WOODFORD - ADDITION  
2121 WAYNOKA ROAD  
COLORADO SPRINGS, CO 80915  
EL PASO COUNTY, COLORADO

DATE: JUL 27, 2018  
DRAWN BY: J. CANTERBERRY  
PROJ. MGR: J. BUTLER  
SCALE: SEE PLAN  
APPROVED BY:  
JOB NO. 934

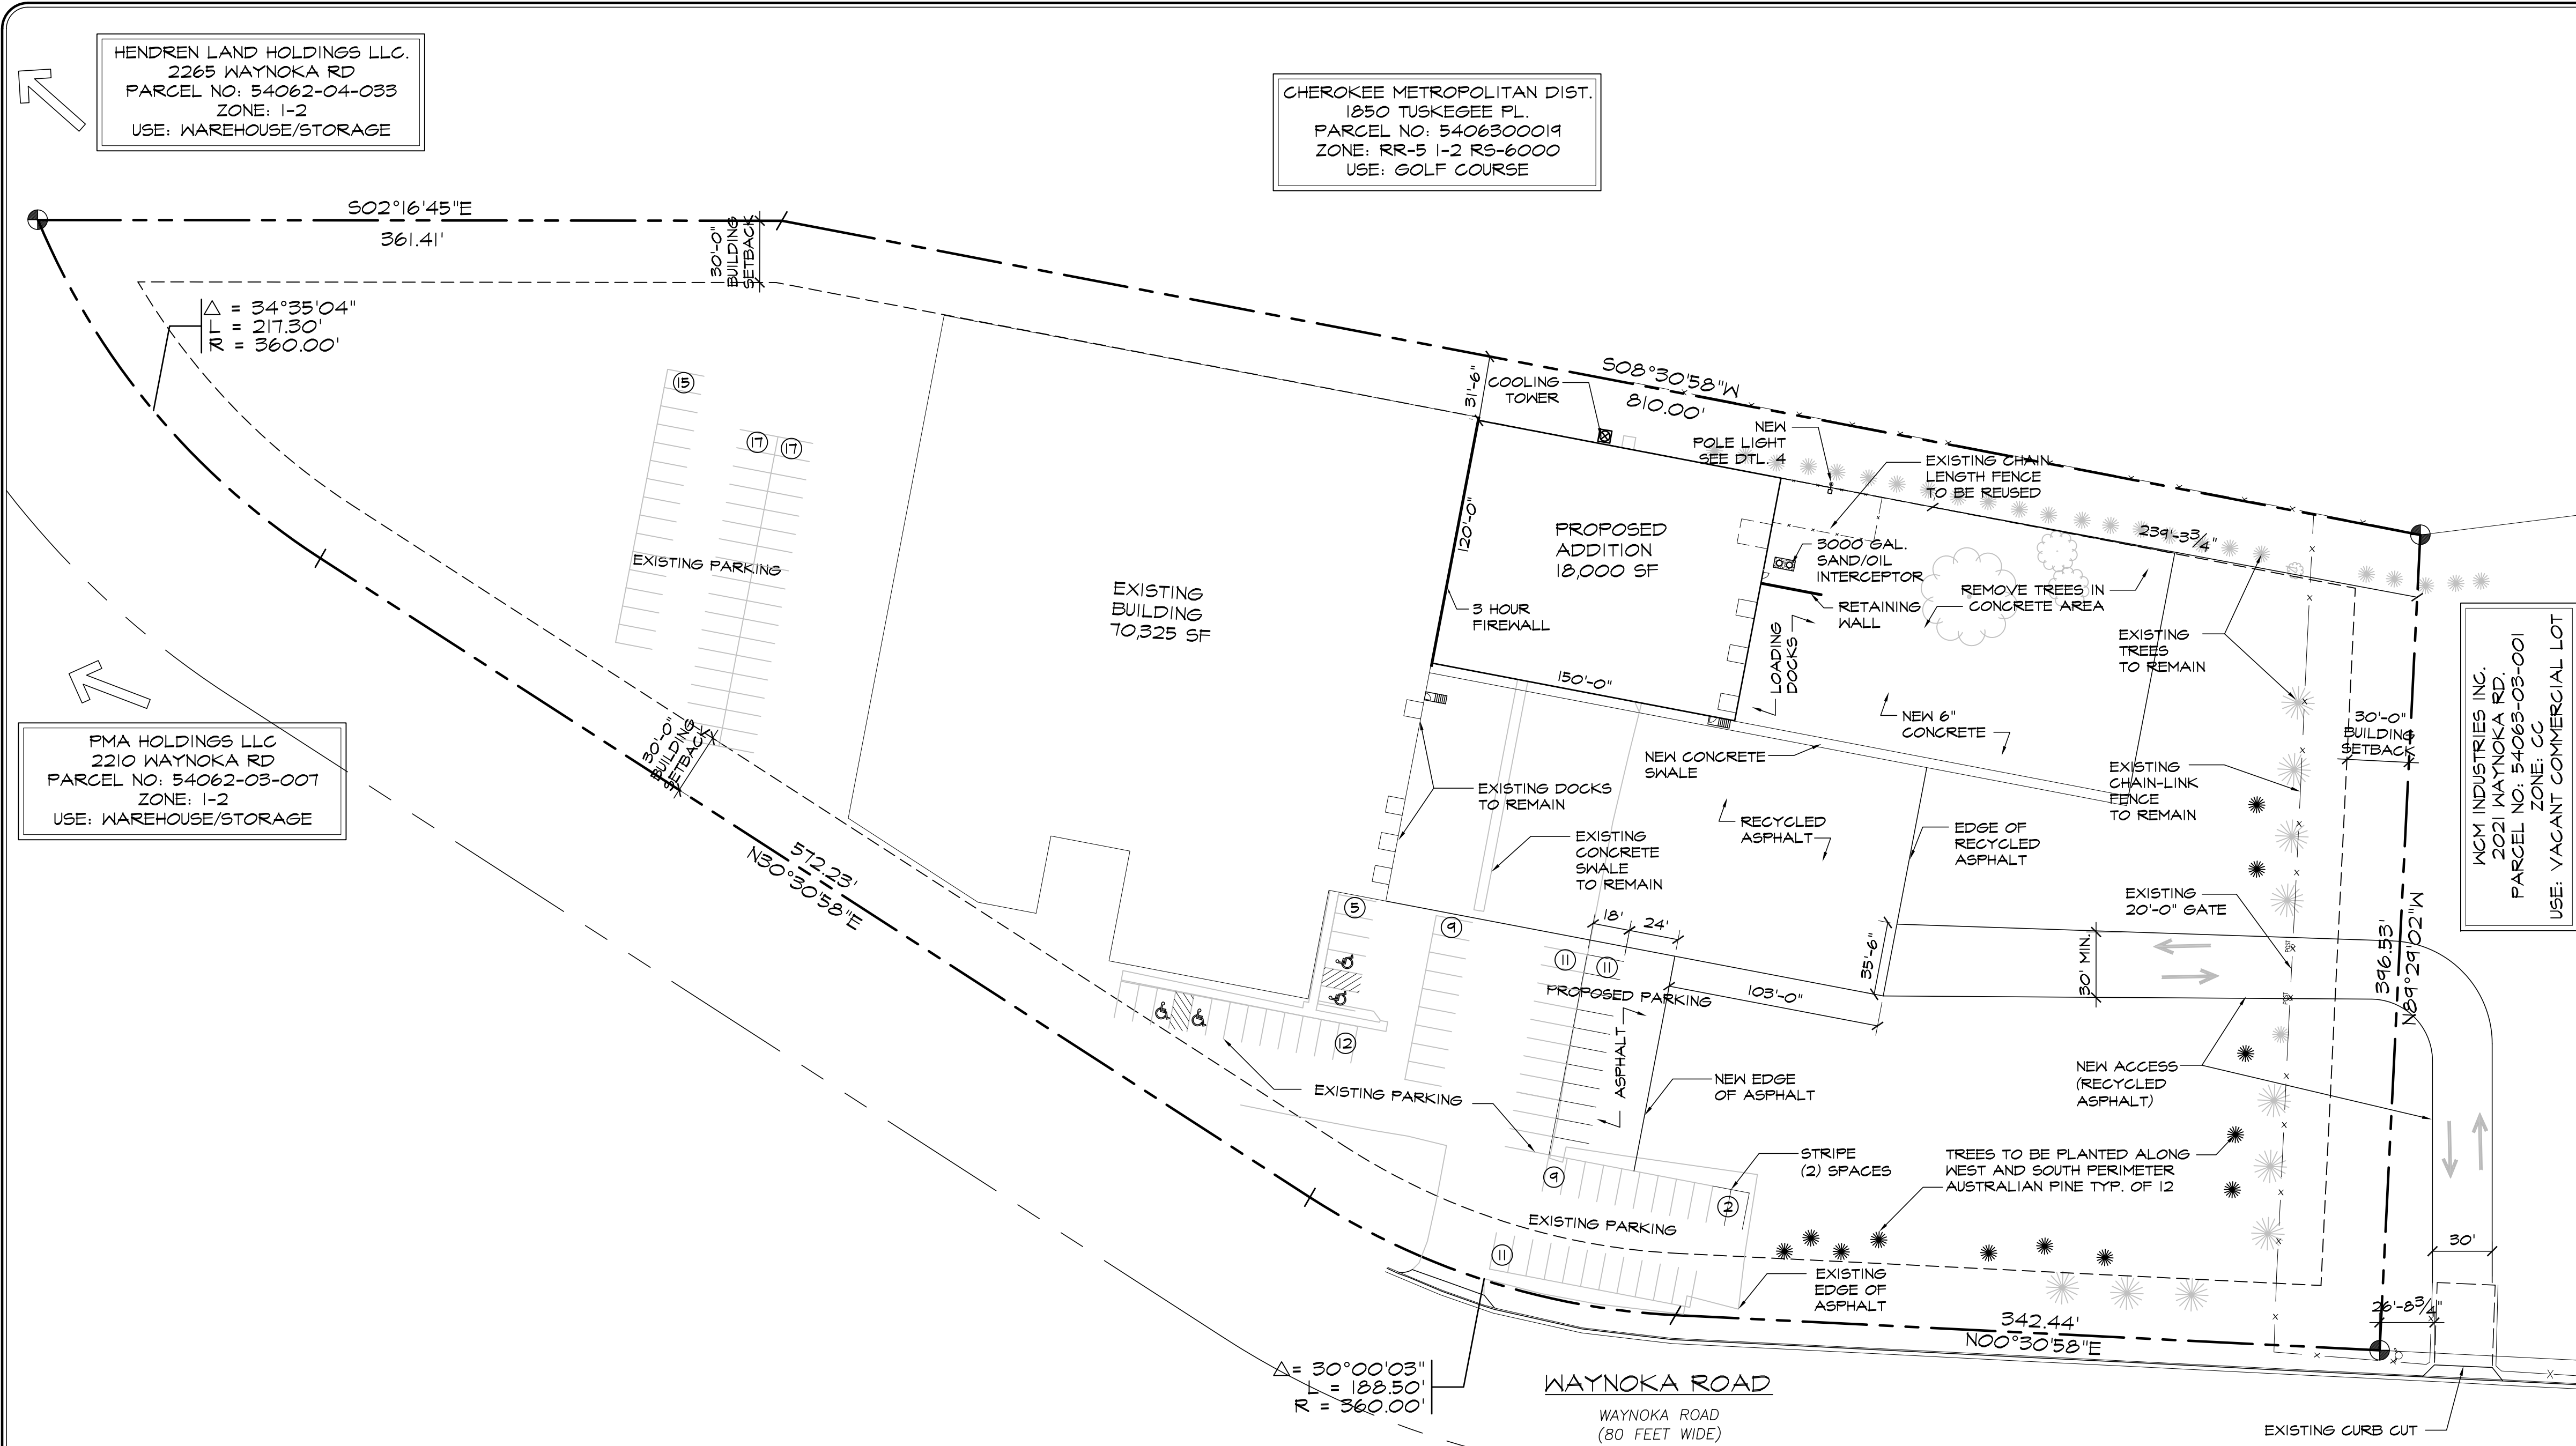
If this is the Landscape Plan, include a table (road length, standard ratio, required/proposed) showing how this property meets the landscape standards in Ch. 6 of the LDC in regards to roadway landscaping, parking lot landscaping, internal landscaping and any buffer areas. Explain why parking lot landscaping is not required.
